UNITED STATES PATENT AND TRADEMARK OFFICE

APPLICATION NO.	FILING DATE	FIRST NAMED INVENTOR	ATTORNEY DOCKET NO.	CONFIRMATION NO.
10/574,582	04/04/2006	Toshiya Hamada	284463US6PCT	9315
22850 7590 02/17/2011 OBLON, SPIVAK, MCCLELLAND MAIER & NEUSTADT, L.L.P. 1940 DUKE STREET ALEXANDRIA, VA 22314				
EXAMINER HARVEY, DAVID E				
ART UNIT 2481		PAPER NUMBER		
NOTIFICATION DATE 02/17/2011		DELIVERY MODE ELECTRONIC

Office Action Summary

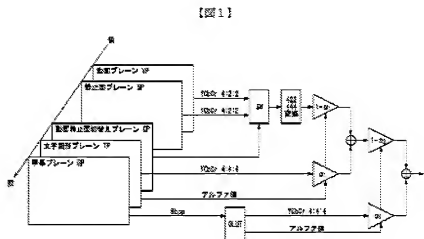
B) As shown in Figure 1 (reproduced below), Nakayama illustrates conventional image synthesizing circuitry that is analogous to that shown in the applied prior art discussed above; i.e., Yeh et al. and Miyamoto et al.

Nakayama has been cited because for its "alternative", if not simply more detailed, showing of the circuit configuration used for blending and combining the data of the character/graphics planes (@ CP, GP) with the selected data, i.e., selected pixel-by-pixel (@ "SW"), of the respective image planes (@ VP, SP). As illustrated, the blending/combining circuitry includes respective sets of a blending units [i.e., @ $\alpha 1$ and $(1 - \alpha 1)$ and @ $\alpha 2$ & $(1 - \alpha 2)$] for adjusting the opacity of the data being combined/blended followed by respective adding units.

B) Yeh et al does not disclose the structure required to implement the α -“blenders” of the modified system (e.g., @ 1141 and 1151 of Figure 11 Yeh et al). However, the examiner contends that the circuit structure required to implement such α -“blenders” was notoriously well known in the video mixing arts as evidenced via Figure 1 of Nakayama in the “same” environment. As such, the examiner maintains that it would be obvious to have implemented the blenders in the modified system of Yeh et al using the conventional configuration shown in Figure 1 of Nakayama given that the Nakayama at least represents an “alternative” configuration of said circuitry; e.g., it was obvious to substitute one embodiment for the other.
